ATTACHMENT 1

REVISED TECHNICAL SPECIFICATION

PAGES TO DELETE FIGURE 3.5.2-4

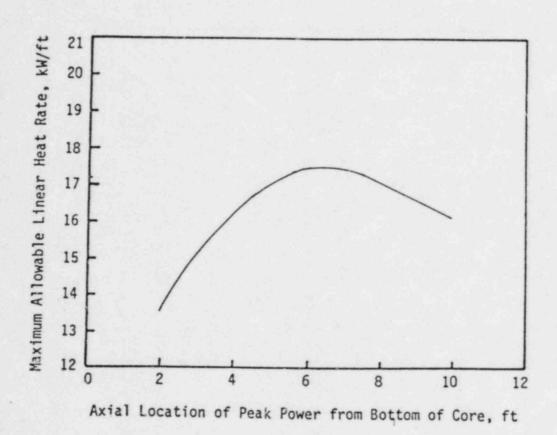
- 3.5.2.6 Reactor Power Imbalance shall be monitored on a frequency not to exceed 2 hours during power operation above 40% rated power. Except for physics tests, imbalance shall be maintained within the envelope defined by Figure 3.5.2-3. If the imbalance is not within the envelope defined by Figure 3.5.2-3, corrective measures shall be taken to achieve an acceptable imbalance. If an acceptable imbalance is not achieved within 4 hours, reactor power shall be reduced until imbalance limits are met.

The power-imbalance envelope defined in Figure 3.5.2-3 is based on (1) LOCA analyses which have defined the maximum linear heat rate such that the maximum cladding temperature will not exceed the Final Acceptance Criteria and (2) the Protective System Maximum Allowable Setpoints (Figure 2.3-2). Corrective measures will be taken immediately should the indicated quadrant tilt, rod position, or imbalance be outside their specified boundaries. Operation in a situation that would cause the Final Acceptance Criteria to be approached should a LOCA occur is highly improbable because all of the power distribution parameters (quadrant tilt, rod position, and imbalance) must be at their limits while
